Town and Country Planning Act 1990 (As Amended) Local Highway Authority (LHA) Response

Application Reference	18/00083/CON		
LHA Reference	19871		
Proposal	Mixed use urban extension for up to 1000 dwellings, local centre, employment, primary school, community facilities, footpaths/cycleways, A427 Weldon relief road, roads, car parking, balancing ponds, formal and informal open space, landscaping and associated development		
Location	Weldon Park, Corby		
Date consulted	8 th October 2018	Date sent	31 st October 2018

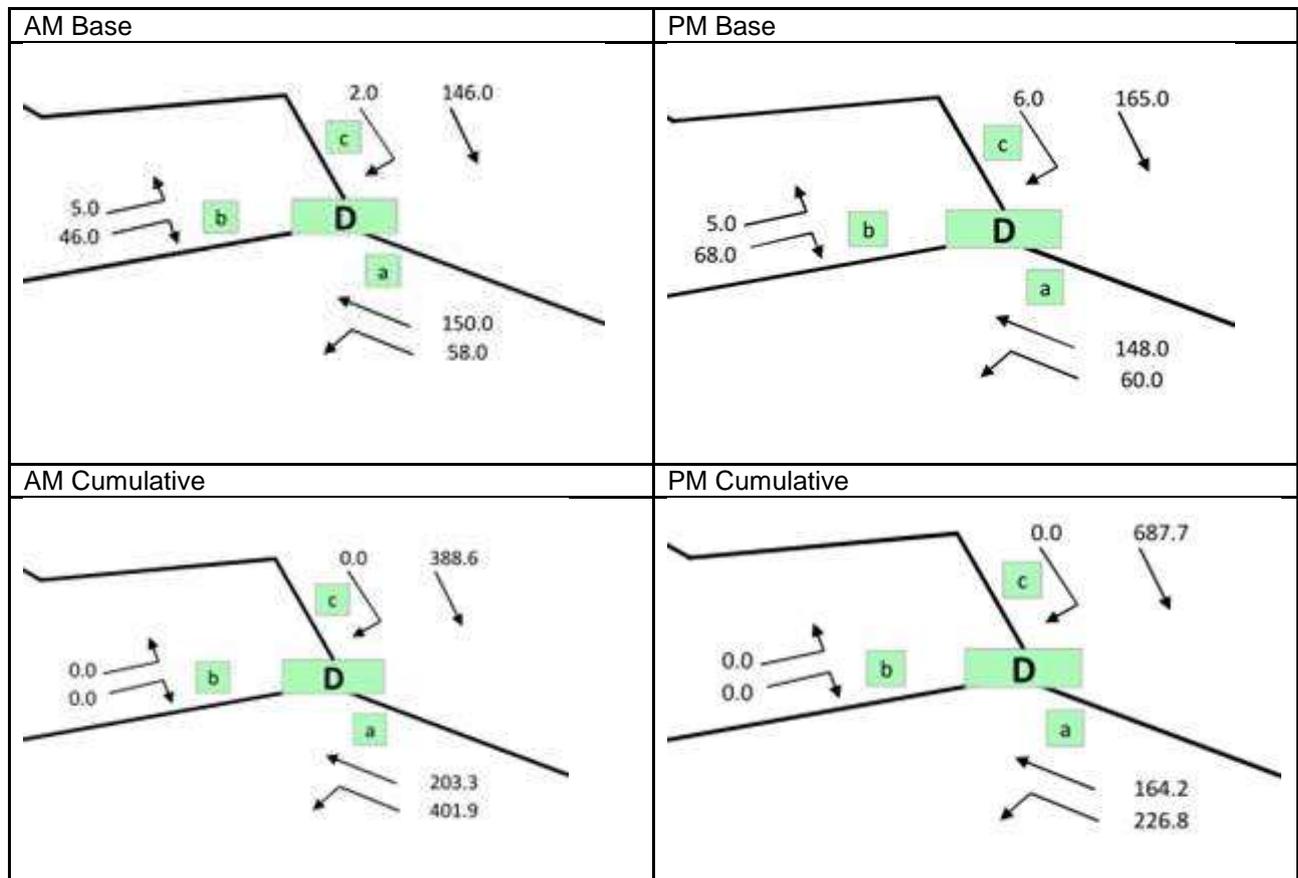
- 5.2 It is, therefore important to look carefully at the impacts of allowing movements that were previously restricted. We have, therefore interrogated the flow diagrams within the submitted Technical Note and noted a number of matters that are of concern.
- 5.3 In particular the additional movements along Church Street. To illustrate this, we have extracted below the AM and PM network diagrams for the A427 / Church Street junction (Junction D):

- 5.4 Attention is drawn to the existing flows and turning movements into Church Street. It can be seen that in the Base Line AM there are 150 movements straight on the A427 (from the development direction) with 58 vehicles turning left down Church Street. In the PM it is similar, 148 and 60 movements respectively.

- 5.5 However, looking at the cumulative flows, the same junction will see 203 movements straight on in the Am peak and 402 turning into Church Street. The PM case shows 164 straight on and 227 turning into Church Street. Clearly if higher trip rates are used and movements from through movements turn at the roundabout into Weldon then the volumes would increase.

- 5.6 You will be fully aware of the width, alignment and nature of Church Street. In our view, such a substantial increase in movements along Church Street is fundamentally unacceptable in safety and capacity terms. The road is simply unsuitable in its current form to accommodate such traffic levels. Clearly you may also have a view in residential amenity terms.
